—  
P21110-FCH-XX-XX-RP-A-0003  
PLANNING APPLICATION PROPOSED AMENDMENTS - OVERVIEW  
APPLICATION REF: 120149/FO/2018  
—

# Planning Application Proposed Amendments - Overview

Ducie Street,  
Manchester,  
M1 2JQ

## 08 PROPOSED PERFORATED PANEL

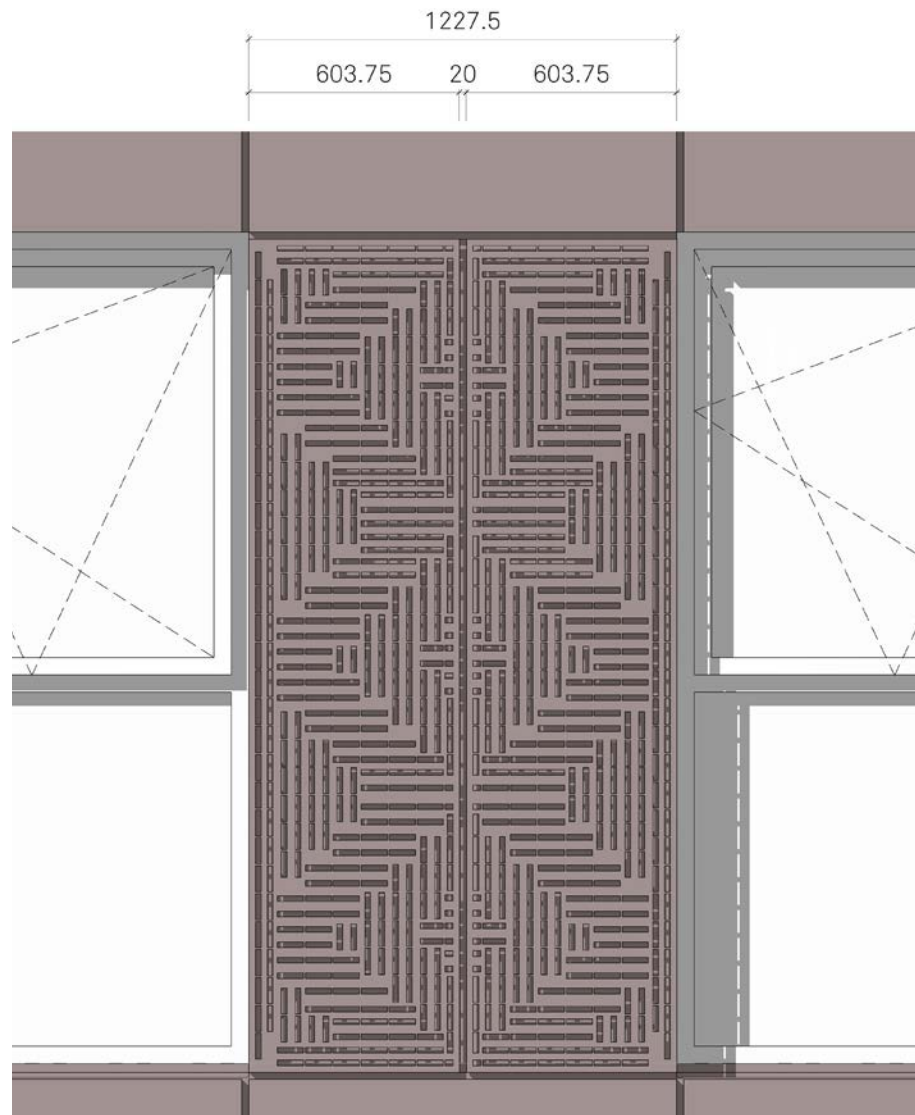
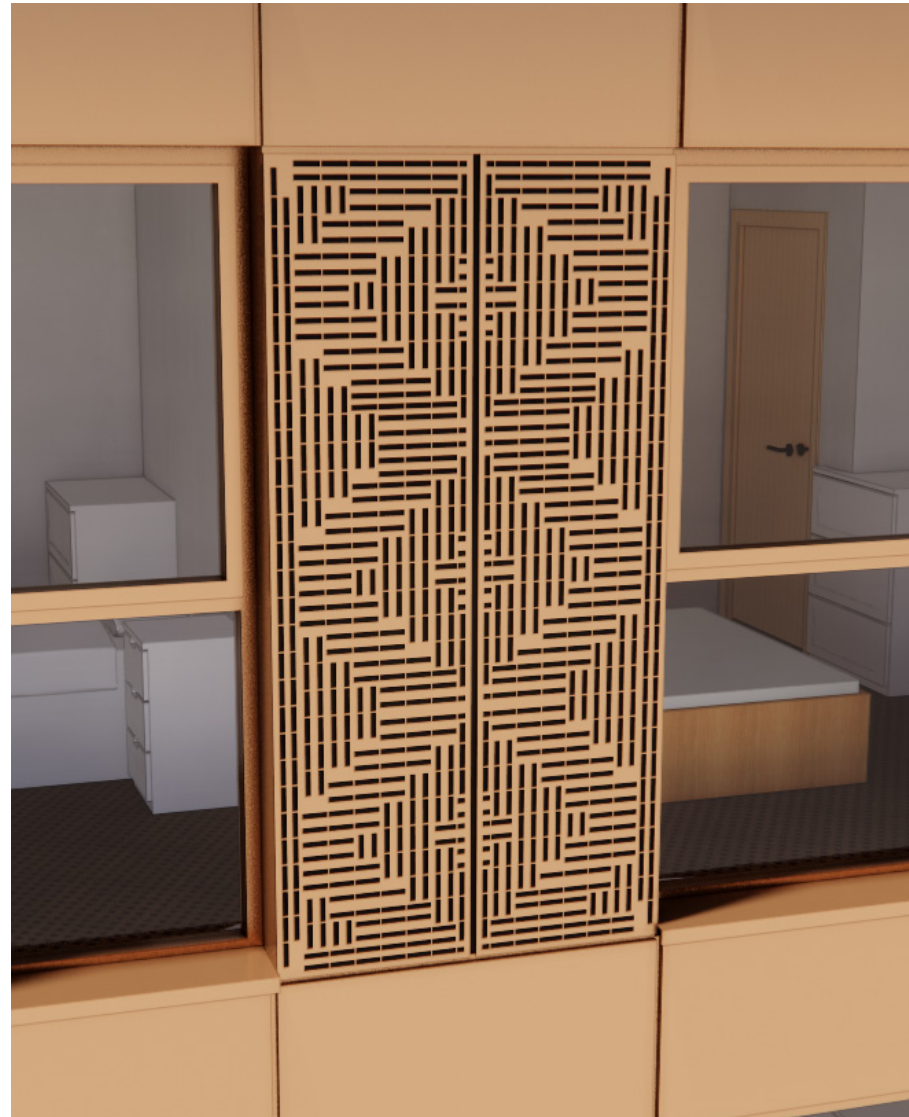
Please refer to pages 7-10 for comparative elevations showing the metal cladding panels and page 17 for illustrative diagrams. Panels have been split vertically in the centre to limit visual impact of the new joint.

Elevation of vertically split perforated panel on south-west / north-east elevations

## 09 MINOR AMENDMENT TO SOLDIER BRICK COURSE

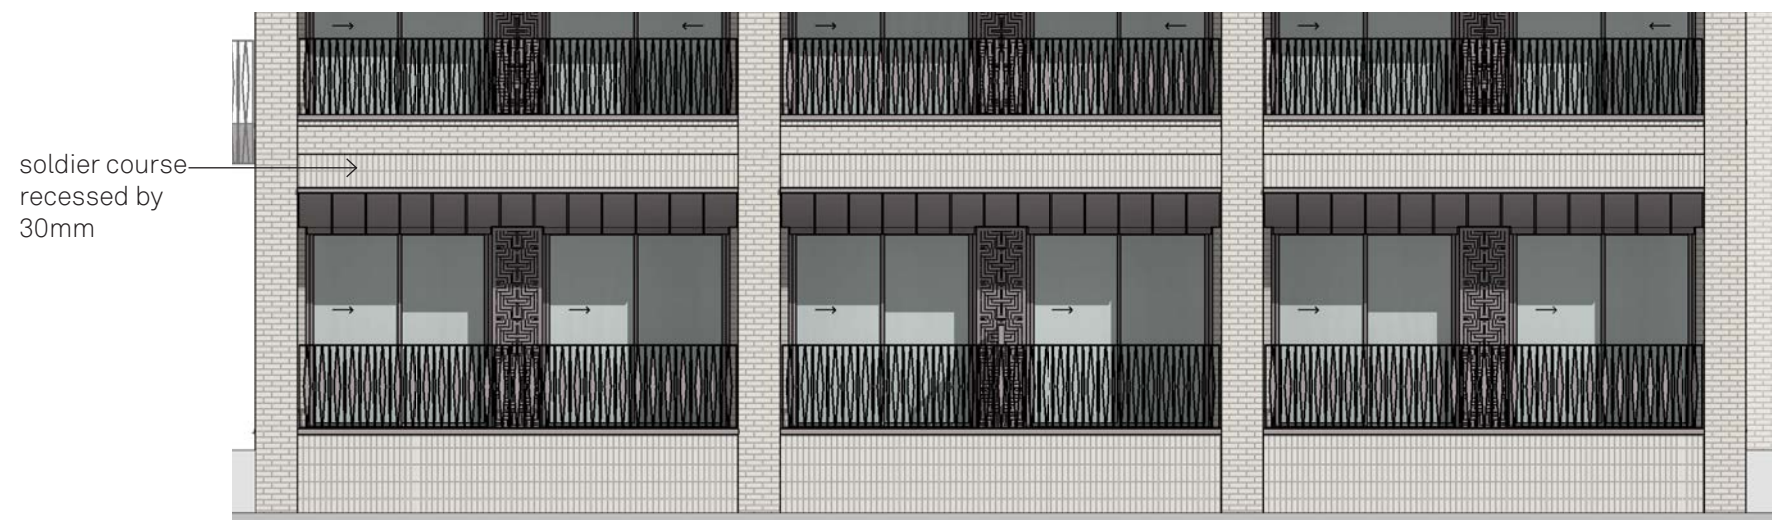
It is proposed to marginally reduce extent of the soldier coursing due to complications in installing the masonry support and achieving tolerances on the structural frame.

This means that the soldier coursing in this location would need to be recessed by 30mm in order to maintain suitable bedding onto the masonry support.

Since we have 30mm recessed brickwork elsewhere on the project it is felt that this ties in with current design language. It would also offer visual relief to the planar elevation, enhancing it's appearance.

The original proposal wrapped the soldier coursing around the corners and across the vertical piers - however our opinion is that limiting the recessed soldier coursing to above the balcony openings enhances the vertical proportion of this facade and the legibility of the balcony openings.
